Planning Commission

Wednesday, January 21, 2026

**TECHNICAL REVIEW PLAT REQUIREMENTS
REGULAR PLANNING COMMISSION MEETING
January 21, 2026**

**Corpus Christi Transportation Master Plan “Mobility CC” Developer Amendment
Request– Removal of Two Proposed C1 Collectors**

PLAT OF
EL OSO DORMIDO
LOTS 1R & 2, BLOCK 1

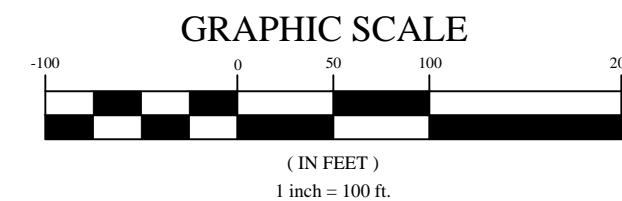
Comment ID	Page Reference	Annotation Type	Author : Department	Status	Review Comments	Applicant Response Comments
1	P001	Note	Mark Zans : DS	Closed	<p>Be advised that by marking the 30 day review time on the application that you may not have time to respond to comments and that the plat will be taken to PC with a recommendation of denial if there are open comments not yet addressed. To solve this issue please send a e-mail to me or respond that you would like to change to the 60 day review time.</p>	
3	P001	Note	Bria Whitmire : DS	Closed	<p>Update 12/24/25: Label private UE separately from the public UEs. For example, instead of 50' private UE, should show the (2) 15' UEs and then a 20' private UE across the panhandle to assure the private yard line is not placed in a public easement.</p> <p>Add a private U.E. for water service connection across Lot 1 to Lot 2 or provide public improvement plans for a waterline extension.</p> <p>Per UDC 3.8.5.D. Final Plat Review criteria: 4.The tract of land subject to the application is adequately served by the improvements and infrastructure, including water, storm water and wastewater, or will be adequately served upon completion by the applicant of required improvements that meets the standards of Article 8. (Ordinance 032357, 02/23/2021)</p>

5	P001	Note	Mark Zans : LD	Closed	<p>Traffic comments:</p> <ul style="list-style-type: none"> • The proposed plat does not impact or alter the existing Roadway Master Plan. • Proposed Driveway (construction exit / entrance) access to public City Street shall conform to access management standards outlined in Article 7 of the UDC (UDC 7.1.7) • Proposed ROW to reflect as the street(s) design and their pertaining categories/ type as per Article 8 of the UDC (UDC 8.2.1) • The PW-Traffic Department (Right-of-Way Division) is responsible for reviewing and permitting new construction and repairs/modifications to driveways, sidewalks, curb, and gutter, and utility easements. The review and approval of the permit must be approved prior to the issuance of the building permit (issued by DSD). (Refer to Municode Chapter 49-30 for permit requirements.)

6	P001	Note	Mark Zans : LD	Closed	<p>Stormwater comments.</p> <p>Per City of Corpus Christi - Code of Ordinances Ch. 14, Art.X, Sec. 14-1003, a Storm Water Quality Management Plan (SWQMP) is required. The following information is not included with the submittal:</p> <p>Hydraulic calculations based upon established procedures (such as the rational method). This should be done for the predeveloped land and post developed land.</p> <p>An on-site drainage plan, which details the direction of flow (using arrows or contours) and collection structures, including the size and required capacity of the drainage structures.</p> <p>The on-site drainage plan should address how run-on storm water will be handled, including sheet flow entering the site from adjoining property..</p> <p>Please review IDM Ch. 3.05: No Adverse Impacts. For new developments and other improvements that will increase the impervious cover, decrease the time of concentration (Tc), or increase peak flows from drainage areas, mitigation of adverse storm water impacts shall be required. Mitigation methods shall be designed to release the post-development storm water runoff from a site at a controlled rate, which does not exceed the predeveloped peak runoff rate</p>

Comment ID	Page Reference	Annotation Type	Author : Department	Status	Review Comments	Applicant Response Comments
7	P001	Note	Mark Zans : LD	Closed	CCW comment: • Water construction is not required for platting (UDC 1.2.1.D & 8.2.6; Water Distribution Standards).	
8	P001	Note	Mark Zans : LD	Closed	Sewer comment: • Wastewater construction is required for platting (UDC 1.2.1.D & 8.2.7; Wastewater Collection System Standards). <ul style="list-style-type: none"> • There is no wastewater service for this area. • Note that use of existing septic system may be possible if approval is granted by the CC Health Department. 	
9	P001	Note	Mark Zans : LD	Closed	Park development fee: 2 lots x 462.50 = \$925.00. To be paid prior to recording of plat.	
10	P001	Note	Mark Zans : LD	Closed	Fire comments: <ol style="list-style-type: none"> 1) Lot 1R cannot be a landlocked parcel. So, your 50 feet entrance at the roadway shall be extended to the Lot 1R 2) A minimum of 20 feet Fire apparatus access lane shall be provided to within 150 feet from any exterior parts of the proposed house. 3) Fire apparatus access lane must be able to carry 75,000 lbs. weight of fire Truck and be an all-weather surface. 4) When Fire apparatus access lane exceeds 150 feet, a turn-around must be provided. 5) In case Fire truck need to make turn, it must be 28 feet inner turning radius and 45 feet outer turning radius. 6) When any exterior part of the proposed house exceeds 600 feet from the public Fire Hydrant, you must provide one on-site Fire Hydrant.

2	P001	Note	Mark Zans : LD	Closed	As per UDC 4.3.3 minimum lot width for RS-6 zoning is 50 feet. The panhandle of lot 1R needs to be 50' in width to conform to minimum lot width standard.

DEVELOPER REQUEST

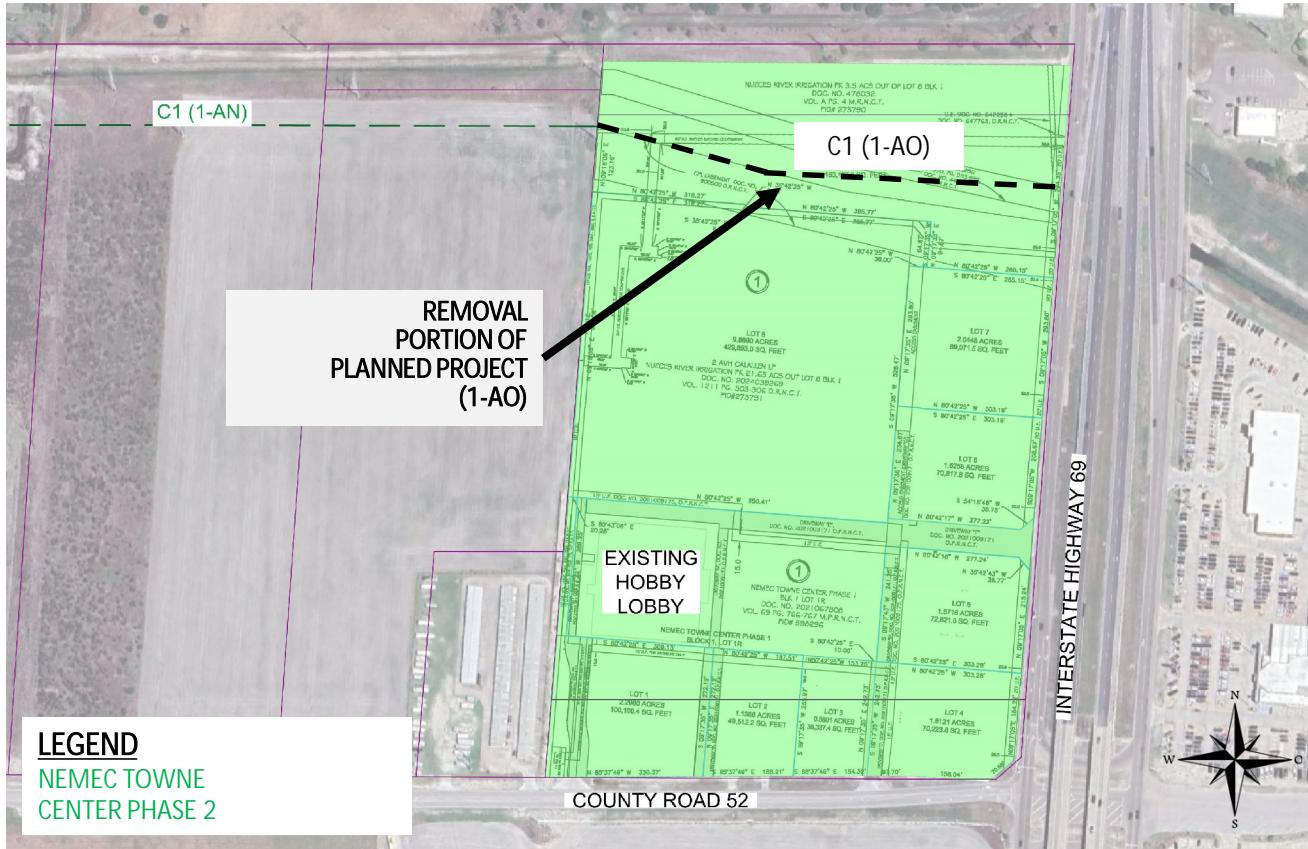
Development	RMP	Classification	Limits	Developer Request
	Project #			
Nemec Towne Center Ph2	1-AO	Proposed C1 Collector	3105' E of CR69 to 4519' E of CR69	Deletion
Meadow Ridge	1-AN	Proposed C1 Collector	1400' E of CR69 to 3105' E of CR69	Deletion
Meadow Ridge	1-AO	Proposed C1 Collector	3105' E of CR69 to 4519' E of CR69	Deletion

PW STAFF RECOMMENDATION

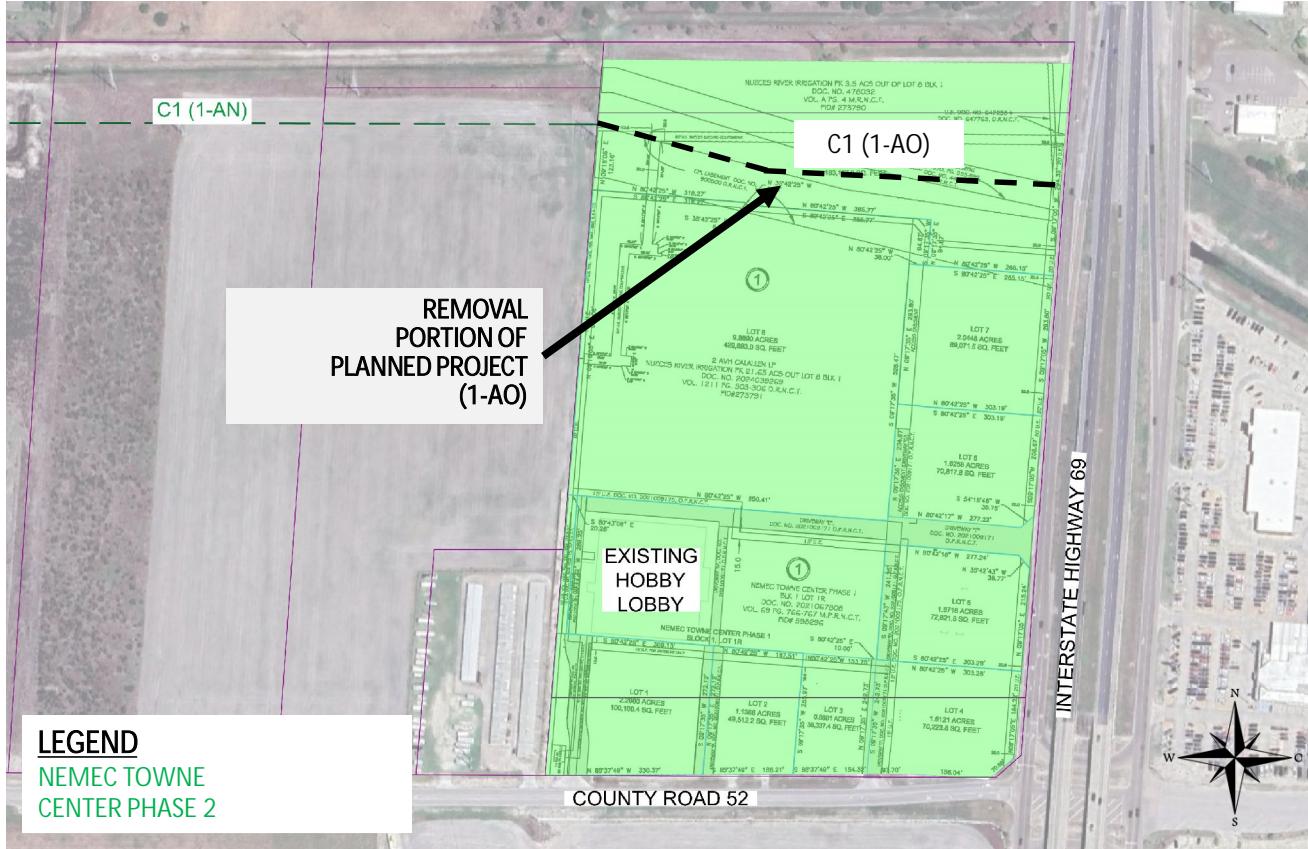
City staff is recommending maintaining both projects on the Transportation Master Plan. However, Project 1-A0 is recommended to terminate at the (east) property line in a cul-de-sac. Staff support is based on the following:

1. The approved Preliminary Plat for River Ridge Unit 4 shows a proposed east/west connection created south of the AEP easement. This plat was approved in 2020 prior to the approval to the updated Transportation Master Plan in 2024 by City Council. Although the Right-of-Way dedication is shown to be 50-ft, it still maintains the intent of the newly adopted Transportation Master Plan.

2. Conformity to *Unified Development Code (UDC) Section 8.2.1.D. External Connectivity* which requires a minimum of two external access points for subdivisions with 81 to 160 buildable lots for the City's existing or future roadway network. The proposed plat only shows one access point onto County Road 52. This is also supported by initial comments from the Corpus Christi Fire Department requiring two points of access to meet Fire Code. Maintaining the Transportation Master Plan provides the second access point to allow connectivity to CR69.

- Delete Project 1-AO from Master Plan.
- Maintain Project 1-AN on the Master Plan.
- Maintain Project 1-AO within boundary of Meadow Ridge subdivision.
 - Maintains required access points for subdivisions with >81 lots (Per UDC Section 8.2.1.D. External Connectivity).
 - Maintains Fire Code requirements for two external access points for public safety.
 - Maintains west connectivity per the Master Plan.

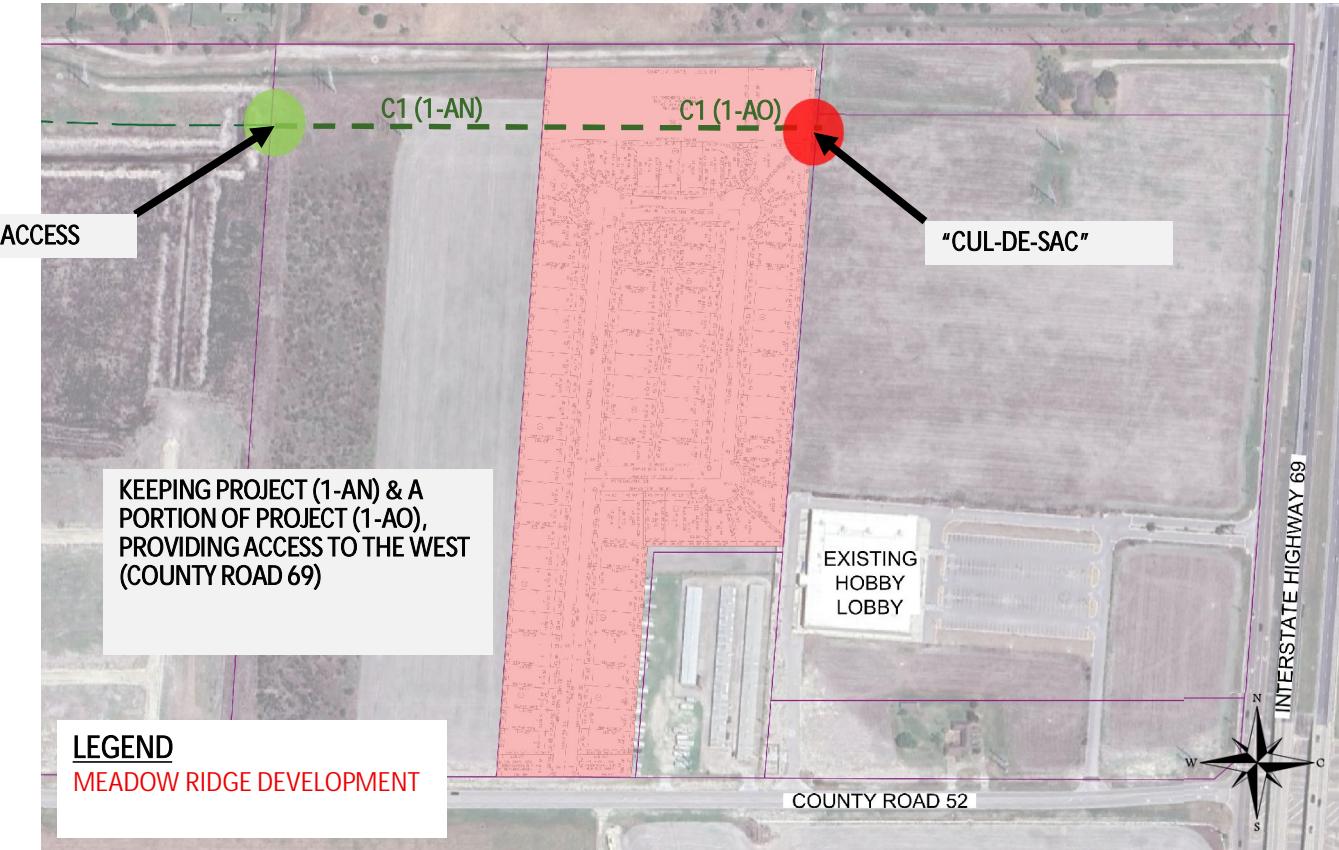
Unless otherwise approved by the Fire Marshal. 14—Note—This plan review indicates that 89 homes will be constructed.

Therefore, per the directives above, two points of access will be required from CR 52. Please submit revised plans indicating these two points of access.

15—Plato—503.2.5 Dead ends. Dead-end fire apparatus access roads more than 150 feet in length shall be provided with an approved area for turning around fire apparatus.

16—Plato—Table D103.4 Requirements for Dead-end fire apparatus access roads. Turnaround provisions shall be provided with a 96-foot diameter cul-de-sac.
